<b>Subject:</b> <b>TRUNK LID UNLOCKING OPERATION CHANGE AFTER DYNAMIC STABILITY CONTROL (DSC) REPLACEMENT</b>	<b>Service Alert No.: SA-048/25</b>
	<b>Last Issued : 10/14/2025</b>

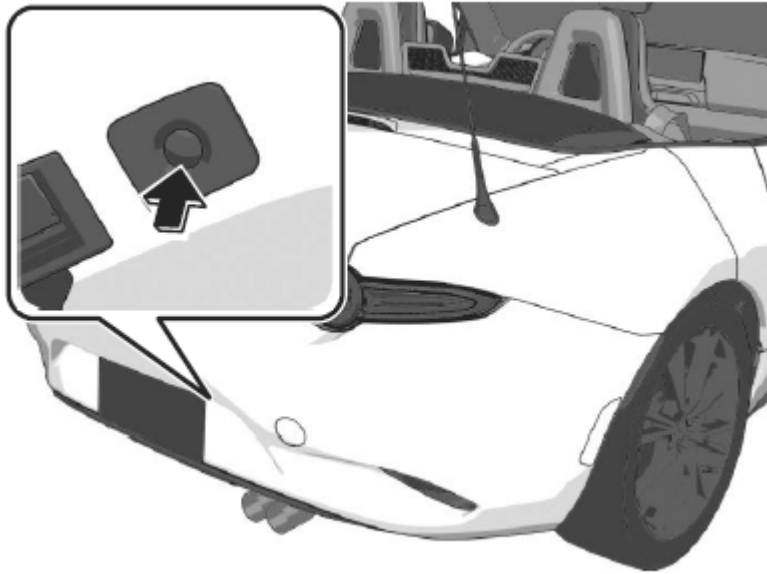
To improved customer experience, an operational modification has been made to unlock the trunk lid after Dynamic Stability Control (DSC) replacement. Be sure to explain the following unlock operational modification to affected customers.

- After the engine is turned off and the vehicle remains inactive for more than 5 minutes (sleep mode), it was necessary to operate the electric trunk lid opener switch **twice** to unlock the trunk lid.
- After replacing the Dynamic Stability Control (DSC) with a newly modified part, the trunk lid is unlocked with a **single** operation, as described in the owner's manual.

Switch Operation in Sleep Mode	Switch Operation <b>NOT</b> in Sleep Mode
Before DSC replacement	Twice	Once
After DSC replacement	Once	Once
